Delegated Decisions by Cabinet Member for Environment (including Transport)

***Thursday, 25 February 2021 at 10.00 am
Virtual***

4. Oxford - Ferry Hinksey Road and Osney Mead: Proposed Shared Use Footway/Cycletrack, Parallel Crossing for Cyclists and Pedestrians and Amendments to Parking Places (Pages 1 - 14)

Report by Interim Corporate Director Communities (**CMDE4**).

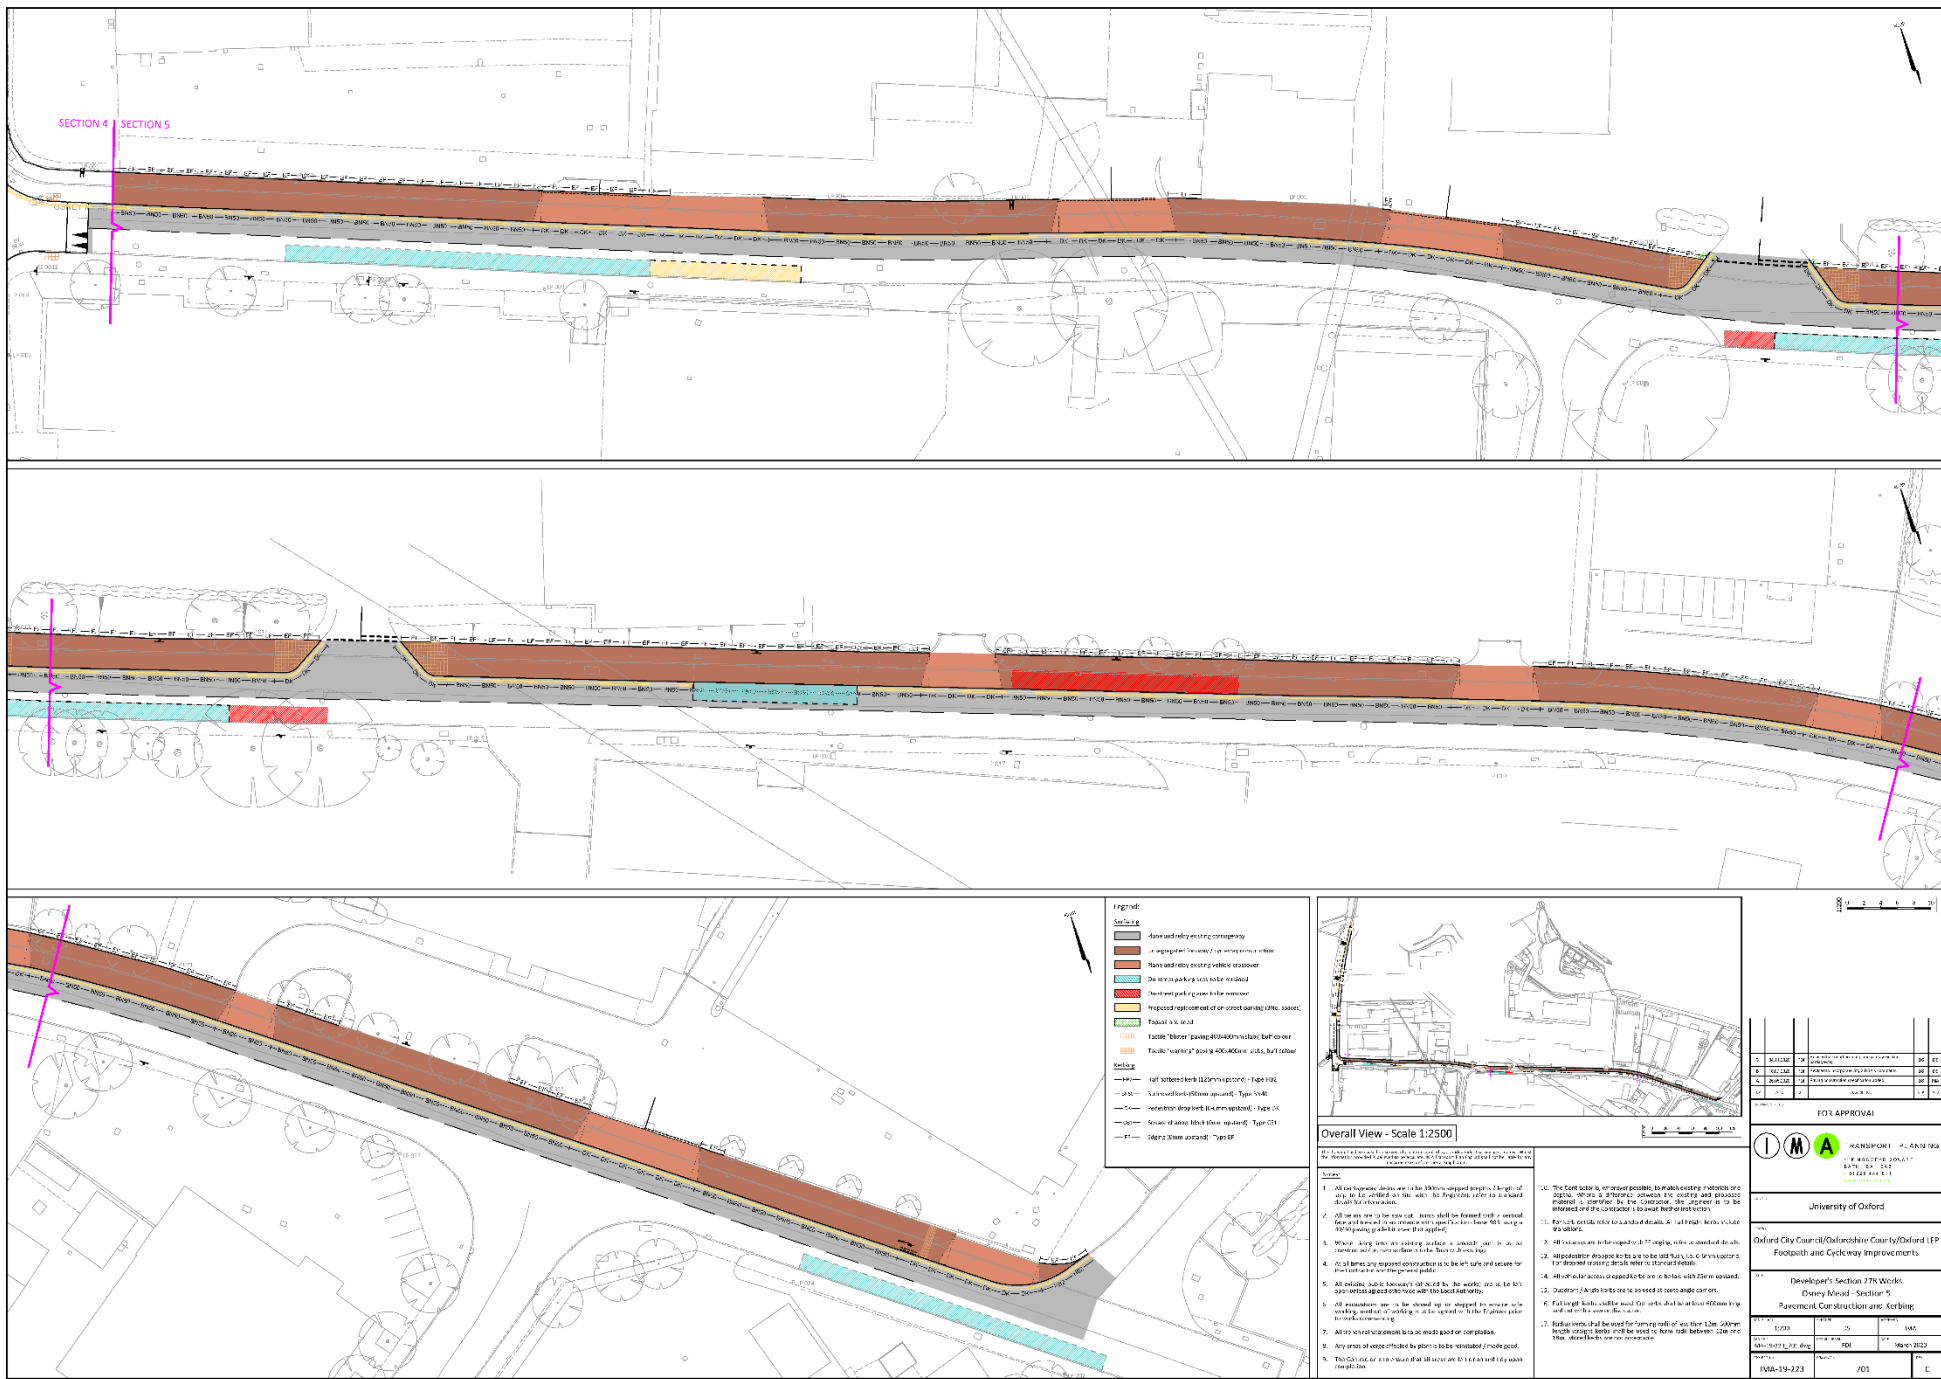
13. Thames Valley Police did not object to the proposals. However, they did raise concerns about the proximity of the Tiger crossing to the Osney Mead junction and that this plan did not allow for the appropriate Zig Zag markings to be provided within the required regulations. Officers have accepted these comments and an amended drawing has been prepared, which does not affect the location of the crossing. A concern was also raised about the crossing being provided directly on the path of cycles exiting eastbound from Willow Walk and that this may result in conflict with turning traffic from Osney Mead. Officers advise that a set of existing bollards on Willow Walk will be retained on the approach to the junction which will also be widened to improve visibility. Officers consider moving the crossing of the pedestrian/cycle desire line is unlikely to alter user behaviour in practice.

RESPONDENT	COMMENTS
(1) Traffic Management Officer, (Thames Valley Police)	<p>Concerns – In principle I am not objecting. However, I do raise serious concern about the design and its close proximity to the Osney Mead Road junction.</p> <p>Can I assume that speed data has already been obtained and current speeds support this design.</p> <p>It is apparent from the drawing No 700 dated March 2020 there are No Zig Zag markings on one side of this crossing which suggests they have been omitted in error or the design is positioned too close to a road junction to allow . I can find nothing in the Regulations that allows this. I understand the drawings have already been audited and I welcome site of any comments.</p> <p>I also note the parallel crossing is directly in line with Willow Walk which may lead to cyclists not Stopping and result in conflict with traffic turning right from Osney Mead.</p> <p>I accept there is a Give Way marking shown on the path approaching the crossing however this in time will fade or become covered by leaves from nearby trees . Offsetting the crossing from directly in line with Willow Walk may help.</p>

(2) Local County Cllr, (Jericho & Osney Division)	<p>Shared-Use Cycle Track - Object Tiger Crossing - Support Parking Amendments - No opinion</p> <p>I very much support making our streets safer and more attractive for pedestrians and cyclists, however, I am totally opposed to footways shared between pedestrians and cyclists. Please find an alternative.</p> <p>It's not clear to me why so much parking is being retained in Ferry Hinksey Road. I believe it's solely or mainly used by commuters and by coaches, which should park elsewhere and have facilities provided.</p> <p>Will all surfaces be raised? This might help to make the streets usable during low-scale flooding.</p>

(5) Local Resident, (Oxford)	<p>Shared-Use Cycle Track - Object Tiger Crossing - No opinion Parking Amendments - No opinion</p> <p>The plan enclosed is bureaucracy gone mad. This part of Osney Mead and Willow walk floods in winter. Plus, has flooded over two weeks ago but pipes underground. Cyclists with carriages attached to back the cycles with babies in also parents with 4/5 year old children behind them on tricycles. Surely, they shouldn't need a cycle sign on the road, as I think the law shouldn't allow the children on the road, especially the Osney Mead. You should erect a sign saying cyclists bring your children out and play on cycles amongst, juggernauts, coaches, lorries etc these cycles of children are motorist's nightmare. Councils started the road at the bottom of Ferry Hinksey Road to take traffic into and out Osney Mead. That road is still there behind businesses on the Mead. Council ran out of money and didn't finish it, so why not spend taxpayer's money on finishing that road, instead of pulling up roads, filling them in and then pulling them up again after a few months in West Oxford especially Botley Road.</p>

(14) Resident, (Kidlington)	<p>Shared-Use Cycle Track - Concerns Tiger Crossing - No opinion Parking Amendments - Support</p> <p>Before and, hopefully, after Covid I cycle this way to work almost every day. I work at Osney Mead House.</p> <p>I don't use the existing cycle path when travelling north along Ferry Hinksey Road because it's too close to parked cars. So getting rid of the parked cars seems like a good plan although I'm not clear from the description whether this is what is proposed.</p> <p>I'm not going to use shared cycle tracks no matter what they are a bad idea always, they'll just be used by drivers as a way to bully people who use the road.</p> <p>My main concern cycling on Osney mead is</p> <ul style="list-style-type: none"> i) There are too many parked vehicles and HGVs etc making navigating them dangerous to cyclists. ii) There are too many pot holes! This is really dangerous to cyclists especially in combination with the above as it can result in loss of control and expending lots of attention on avoiding potholes rather than looking ahead at the road and parked vehicles and other hazards. I'd rather you fixed this than anything else. :(

(16) Resident, (unknown)	<p>Shared-Use Cycle Track - Concerns Tiger Crossing - No opinion Parking Amendments - No opinion</p> <p>I have worked on Osney Mead for 12 years and regularly cycle on and off the industrial estate from all points of entry/exit.</p> <p>In my view, pavements which are shared between pedestrians and cyclists are unnecessary in an area with a 20mph speed limit. The proposed pavements drop each time they pass a vehicular ingress which forces cyclists to slow down and makes it less clear to motorists that we have right of way. I note there is also no plan to lower the kerb at the path</p>

Annex 2: Plan of proposed shared use footway/ cycle tracks, toucan crossings and experimental measures on The Causeway

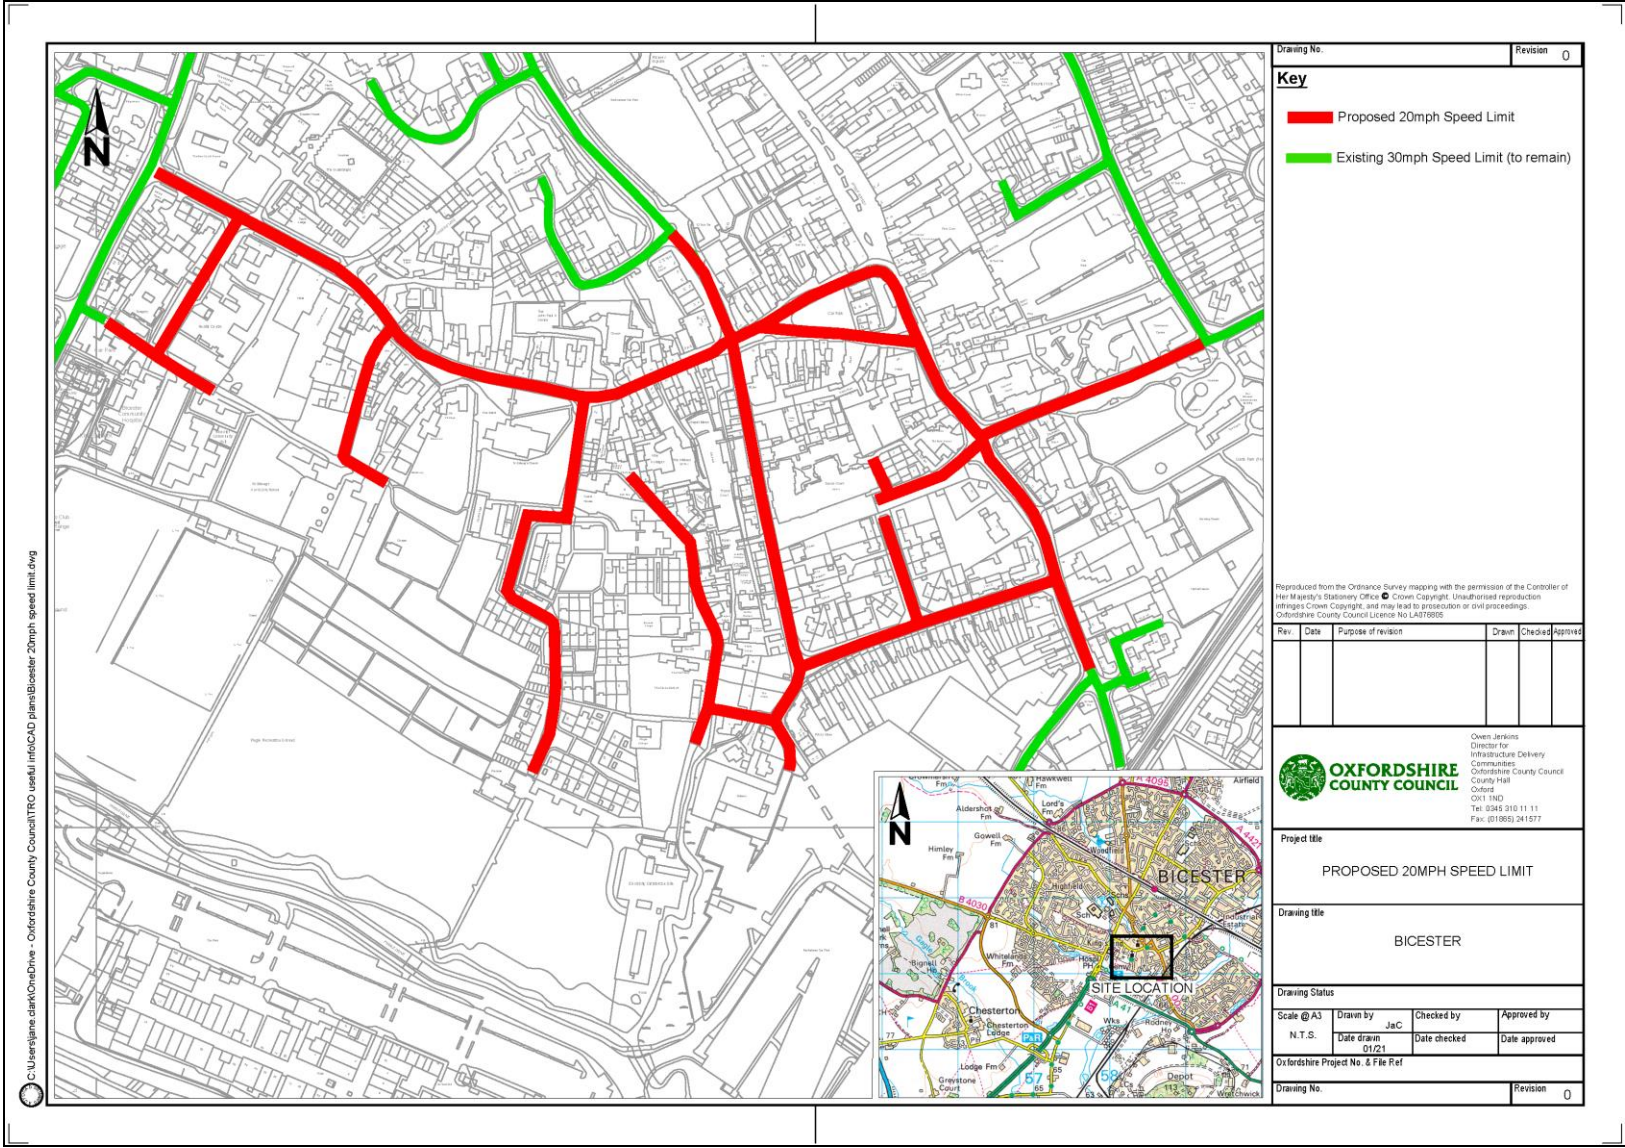
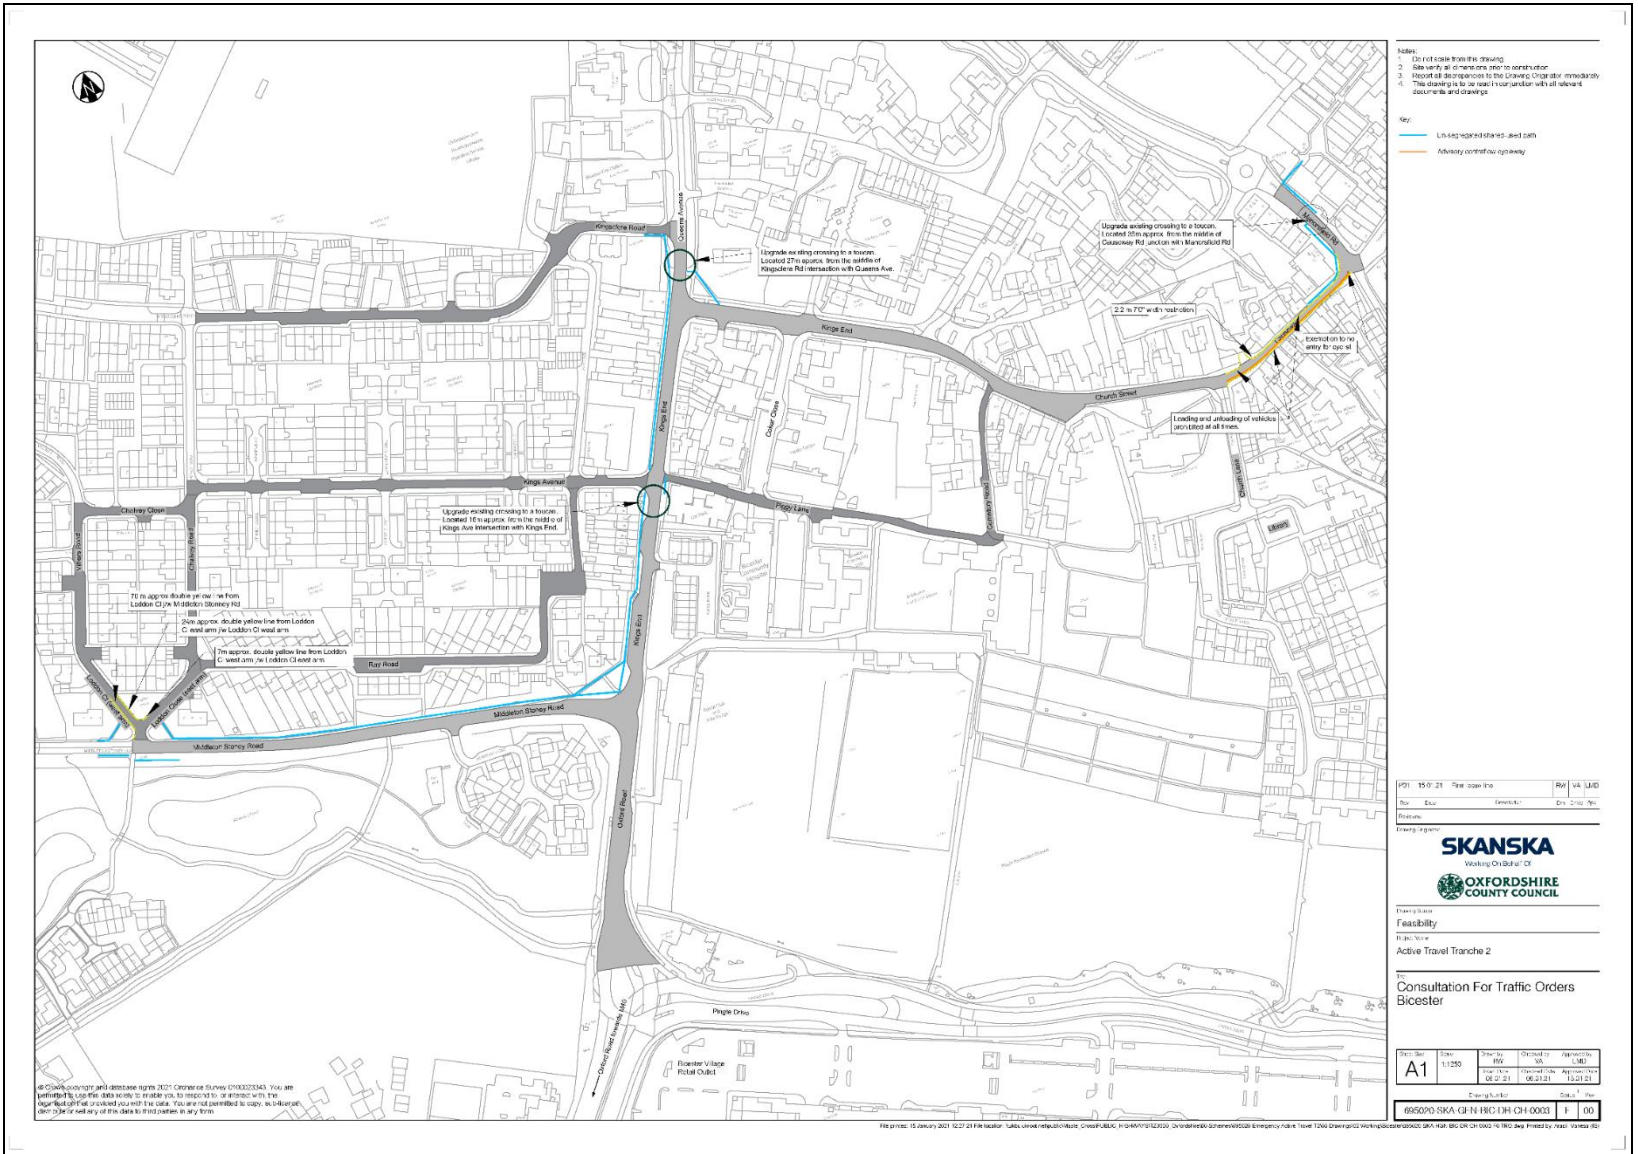
29. Four respondents have objected to the proposals to convert areas of footway to shared-use cycle paths and fifteen voiced concerns. Ideally all the proposals would provide dedicated space for cycling. However, due to the constrained path widths the proposals are unable to deliver segregated paths which meet national design standards. Following on from concerns raised at the stakeholder workshop, the shared path along the section of Middleton Stoney Road within this scheme is now proposed as 3m width, which is the recommended width for shared use paths in LTN 1/20 table 6-3.

31. Four respondents were concerned about the proposed toucan crossing because of the impact on pedestrians who are crossing; 85% supported this element of the scheme. Upgrading existing signalised pedestrian crossings to toucan crossings will allow mounted cyclists to cross the road. Infrastructure will be installed to aid people with disabilities throughout the design, such as tactile paving, and cones/bleepers at the toucan crossings. The proposals can be monitored and reviewed as part of future plans for the central corridor.

(6) Local Group, (CyclingUK Oxfordshire)	<p>20mph Speed Limit - Support Toucan Crossings - Support Shared-use Cycle Paths - Concerns Exp. Parking Restriction - Support Exp. Width Restriction - Support Exp. Loading Restrictions - Support Exp. Contraflow Cycleway - Support</p> <p>This response is from the Oxfordshire Cycling Network.</p> <p>* 20mph speed limit is a measure with a strong record of safety improvement and will a better environment for walking and cycling. * Toucan crossing enables cycle crossing. We prefer a parallel crossing if possible on Kings End, at 20mph this should be quite viable.</p>

<p>* Shared use paths are better than nothing but not ideal in urban settings, particularly when narrow. We support them over 'no change' but prefer facilities where motors, cycles and pedestrians are separated, or where the shared path is 3.0m wide (as LTN1/20) or 3.5m (as P.Lingwood)</p> <p>* We support the experimental parking, loading and width restrictions to enable the cycle routes, but recognise that shops need to receive deliveries, and perhaps timed delivery slots could be set. Emergency vehicle access should be checked.</p> <p>* We support the contraflow cycleway. These have a very good safety record, better than regular advisory painted lanes. We think this should have a post with the width restriction at the west end to sign and protect the lane.</p> <p>We will add further commentary to the consultation response.</p>
